ANN ARBOR HISTORIC DISTRICT COMMISSION

Staff Report

- ADDRESS: 804 W Liberty Street, Application Number HDC14-105
- **DISTRICT:** Old West Side Historic District

APPLICATION: The applicant seeks HDC approval to construct a one-story rear addition with a roof deck, and replace a second floor window with a door.

Proposed Rear Elevation

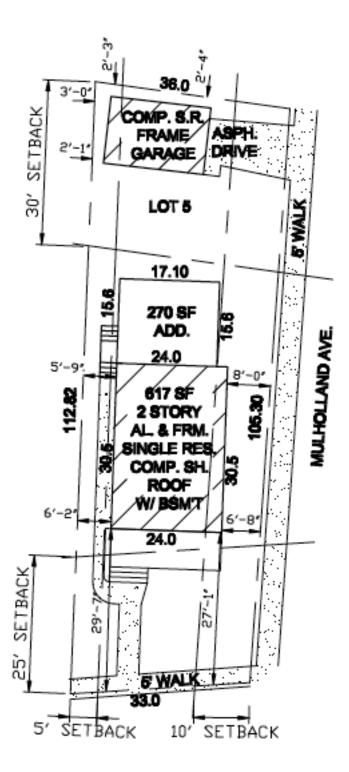
- 3. The rear elevation drawing does not show the new door, though information on two different doors is provided in the packet. The #55 Countryside wood door is most appropriate given that the rear door will be visible from Mulholland.

2 A2.0 WEST ELEVATION SCALE 1/4"=1'-0"

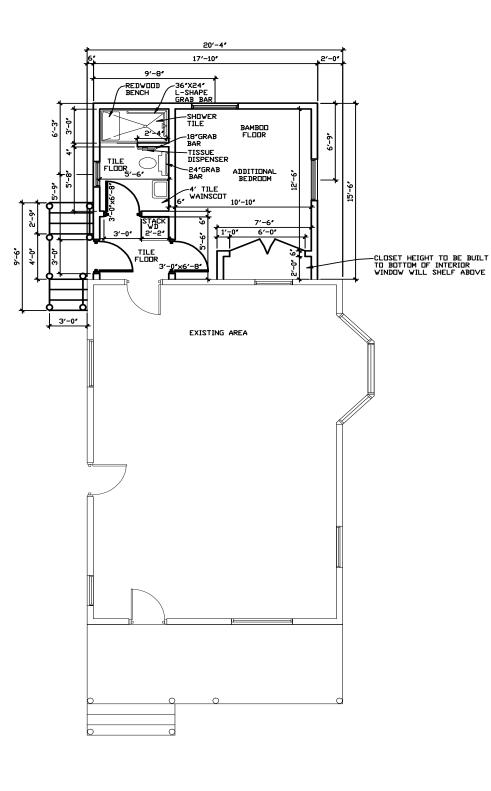
- 2. The addition would have a wood roofdeck with a wood railing (to be painted white), and a matching railing would be installed on the new stairs on the west elevation of the addition. The applicant provided railing detail, but staff suggests a modification to make the railings comply with the Ann Arbor Historic District Design Guidelines the top and bottom rails that attach to the balusters should be on flat instead of on edge. The proposed motion includes this as a condition of approval.
